VIRGINIA ELECTRIC AND POWER COMPANY (DOMINION)
DOMINION NUCLEAR CONNECTICUT, INC. (DNC)
DOMINION ENERGY KEWAUNEE, INC. (DEK)
SURRY AND NORTH ANNA POWER STATIONS UNITS 1 AND 2
MILLSTONE POWER STATION UNITS 2 AND 3
KEWAUNEE POWER STATION
APPROVED TOPICAL REPORT DOM-NAF-2, Revision 0.1-A

Topical Report DOM-NAF-2, Rev. 0.1-A

**REACTOR CORE THERMAL-HYDRAULICS
USING THE VIPRE-D COMPUTER CODE**

Figure 1: Locked Rotor Transient Equilibrium Quality Results at Time 3.0 Seconds

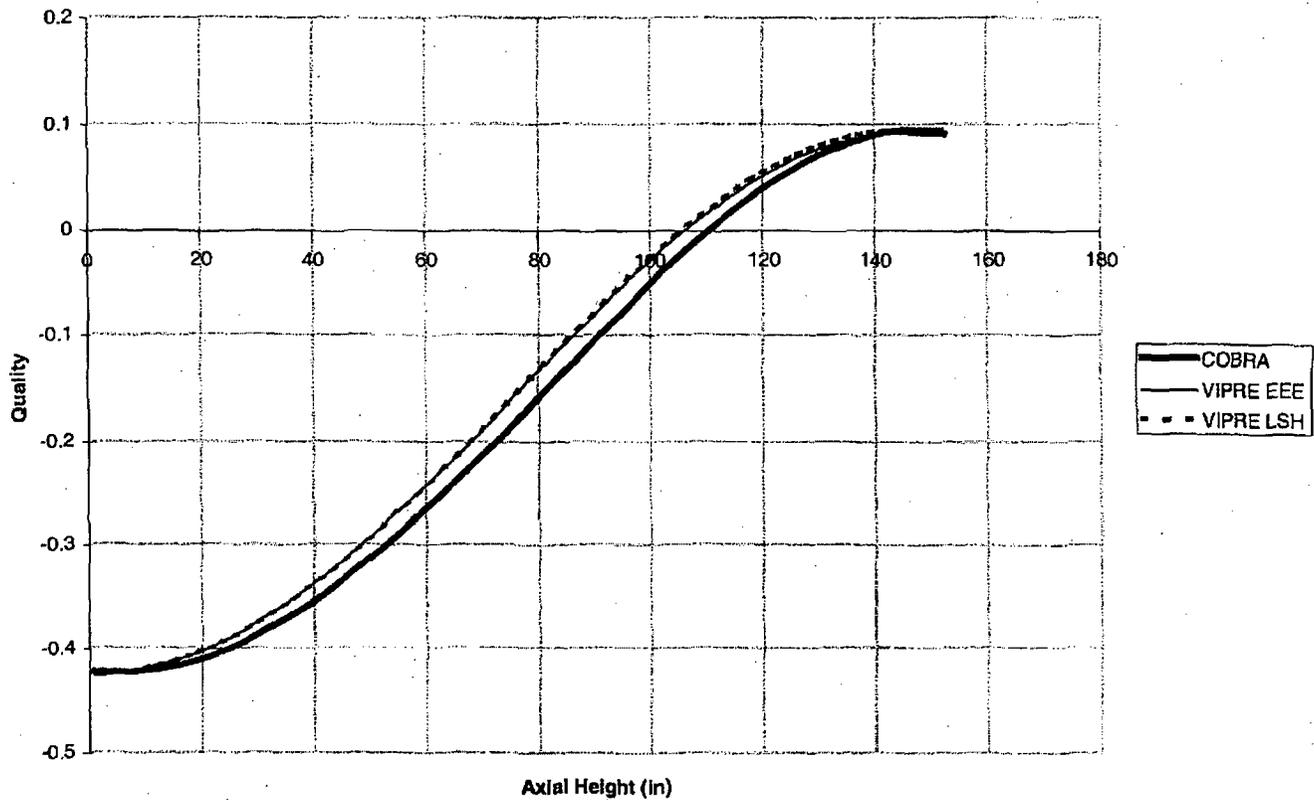
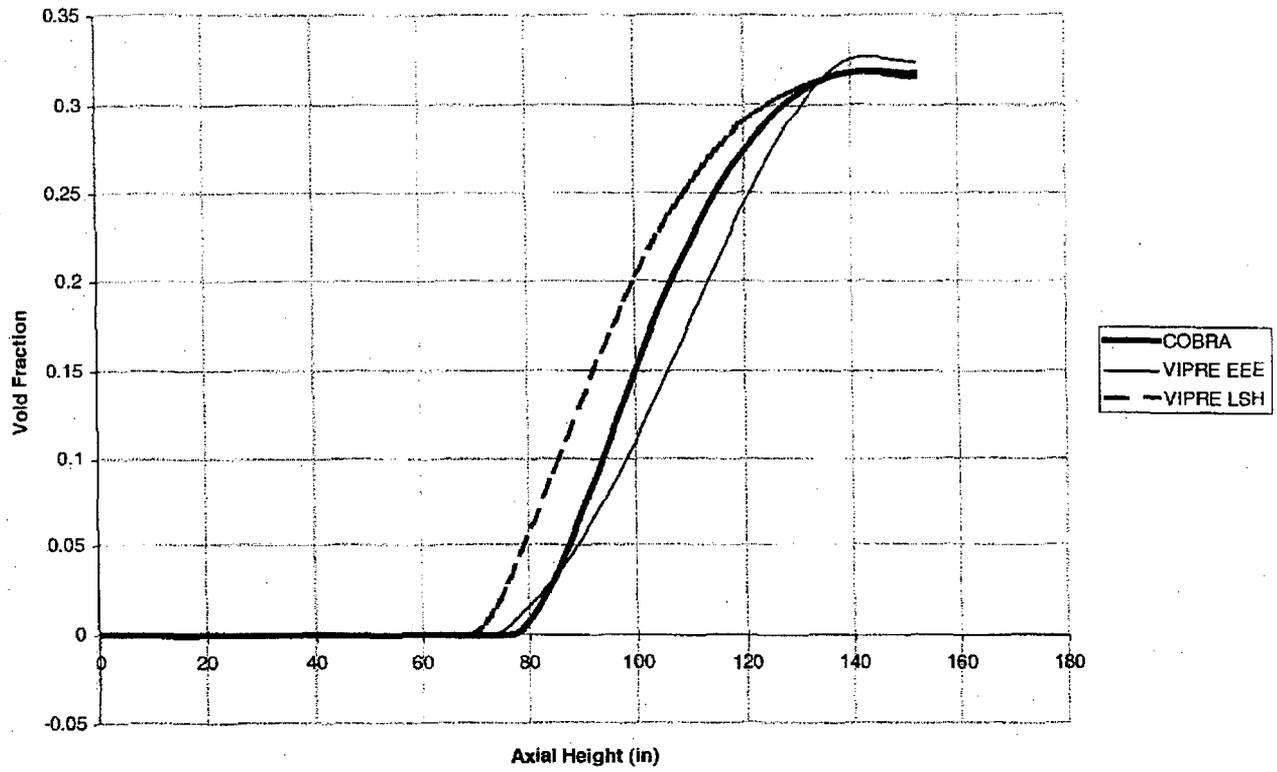
During the May 25, 2005 NRC-Dominion public meeting, Dominion agreed to provide some graphic comparisons to show VIPRE-D's performance for void fraction and quality. Figures 1 and 2 provide a comparison between the VIPRE-D/WRB-1 and the COBRA/WRB-1 codes. In particular, these figures show the void fraction and quality axial distributions in the hot channel at the time of minimum DNBR (3.0 seconds) for a Locked Rotor Transient event at Surry Power Station. Additional description and results associated with this transient were included in Section B.7.3 of Appendix B to DOM-NAF-2. In addition to the VIPRE-D/WRB-1 with the EPRI-EPRI-EPRI set of models, Figures 1

Figures 1 and 2 show that the different void and two-phase friction models result in comparable void fraction and quality trends for COBRA and VIPRE-D. However, as noted above, DNBR comparisons are the main criterion used to evaluate the performance of VIPRE-D against other thermal-hydraulics codes and models. These comparisons demonstrated the acceptability of the EPRI models for bulk void, subcooled void and two-phase friction factor for use in the Dominion VIPRE-D models.

Figure 3: VIPRE-D/BWU-Z Probability Density Function

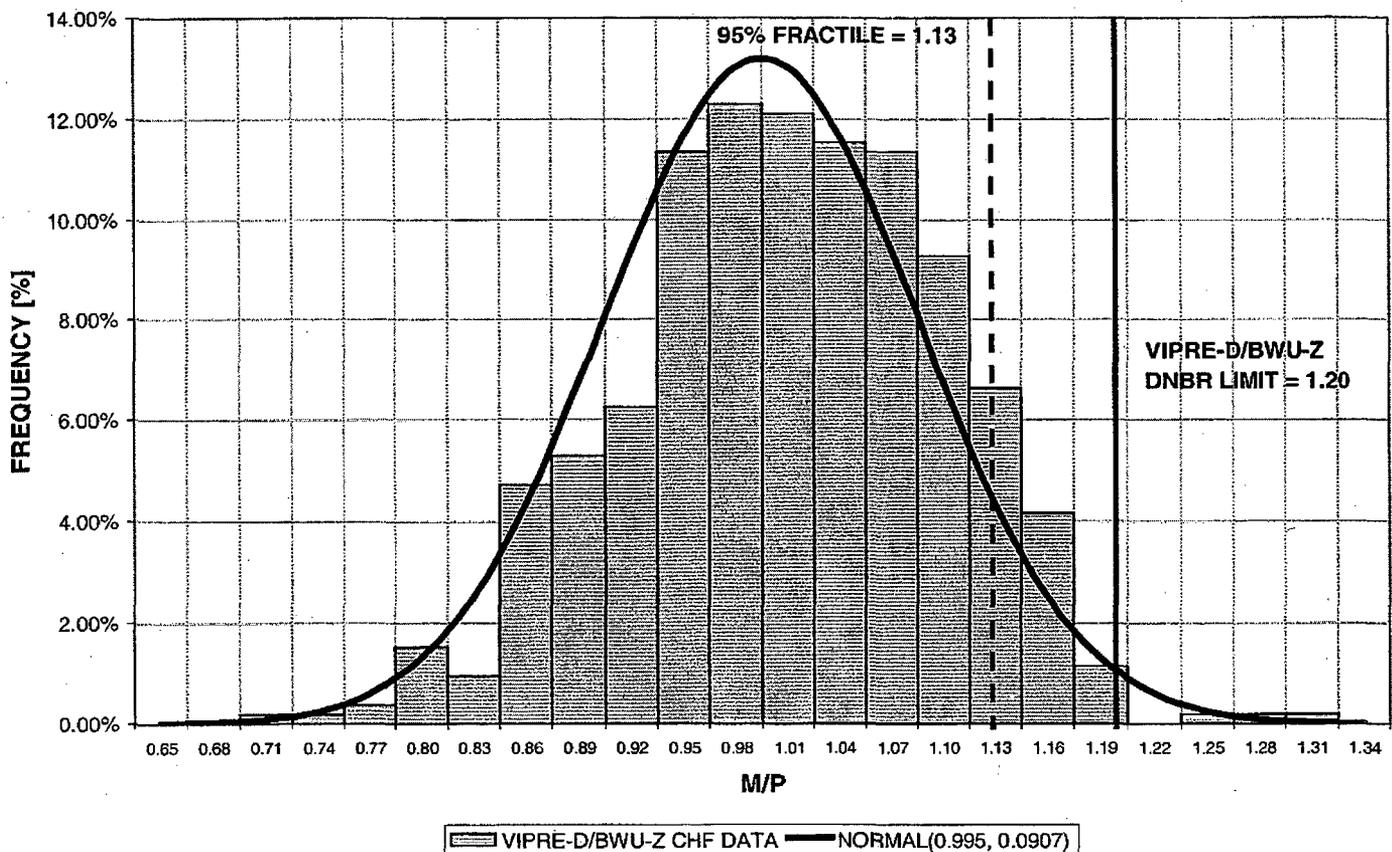
The probability density functions for the BWU-Z, BWU-ZM and BWU-N correlations are shown in Figures 3, 4 and 5.

The 528 datapoints of the VIPRE-D/BWU-Z M/P distribution summarized in Section A.4.1 of DOM-NAF-2 Appendix A were used to create the empirical probability density function. These datapoints were distributed among 24 equal bins that covered the entire range of M/P in the VIPRE-D/BWU-Z distribution, and the frequency of data in each bin was determined. The resulting empirical probability density function for the VIPRE-D/BWU-Z M/P distribution was then compared with the probability density function of a normal distribution of mean 0.995 and standard deviation 0.0907, which are the mean and standard deviation calculated for the VIPRE-D/BWU-Z M/P distribution in Section A.4.1 of DOM-NAF-2 Appendix A. Figure 3 also displays the obtained 95% fractile (1.13) for the data and the VIPRE-D/BWU-Z DNBR limit obtained in Section A.4.1 of DOM-NAF-2 Appendix A (1.20).

Figure 6: VIPRE-D/WRB-1 Probability Density Function

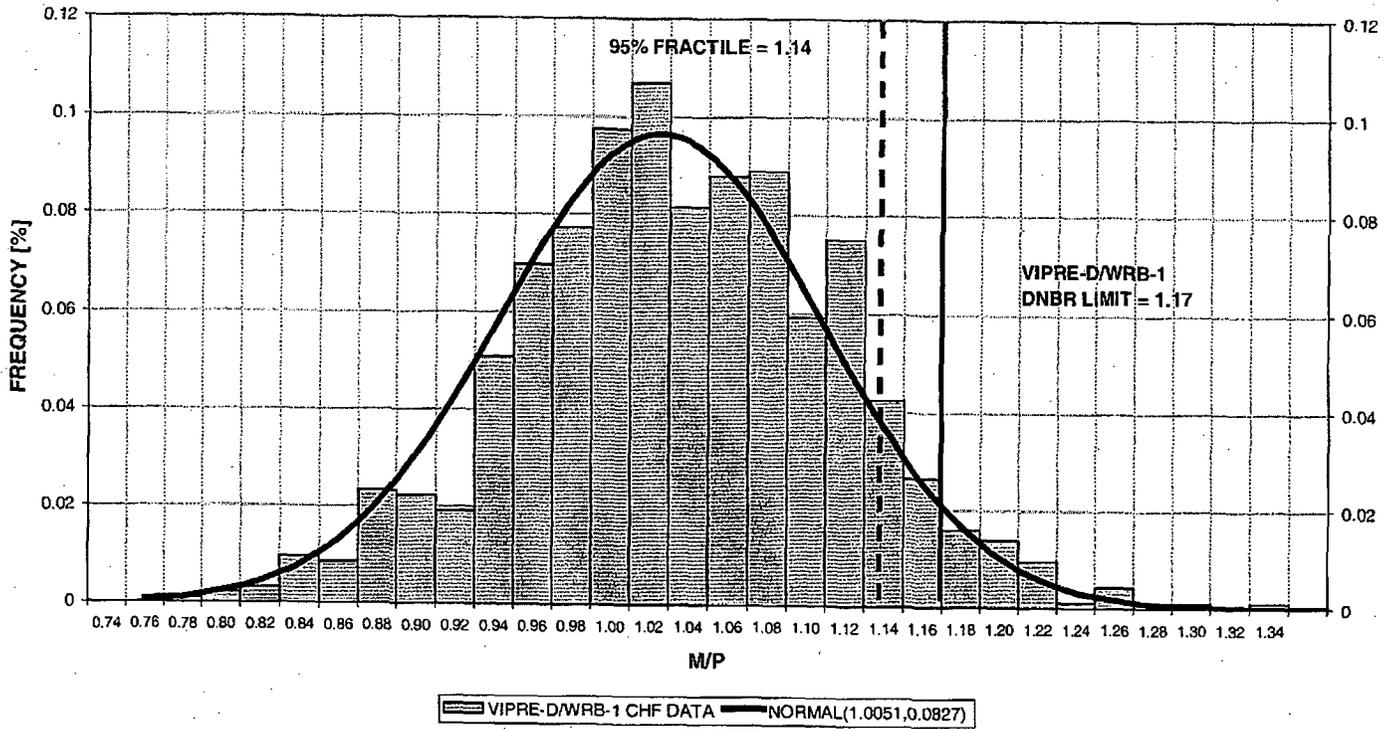
The probability density function for the WRB-1 correlation is shown in Figure 6.

The 945 datapoints of the VIPRE-D/WRB-1 M/P distribution summarized in Section B.6 of DOM-NAF-2 Appendix B were used to create the empirical probability density function. These datapoints were distributed among 31 equal bins that covered the entire range of M/P in the VIPRE-D/WRB-1 distribution, and the frequency of data in each bin was determined. The resulting empirical probability density function for the VIPRE-D/WRB-1 M/P distribution was then compared with the probability density function of a normal distribution of mean 1.0051 and standard deviation 0.0827, which are the mean and standard deviation calculated for the VIPRE-D/WRB-1 M/P distribution in Section B.6 of DOM-NAF-2 Appendix B. Figure 6 also displays the obtained 95% fractile (1.14) for the data and the VIPRE-D/WRB-1 DNBR limit obtained in Section B.6 of DOM-NAF-2 Appendix B (1.17).
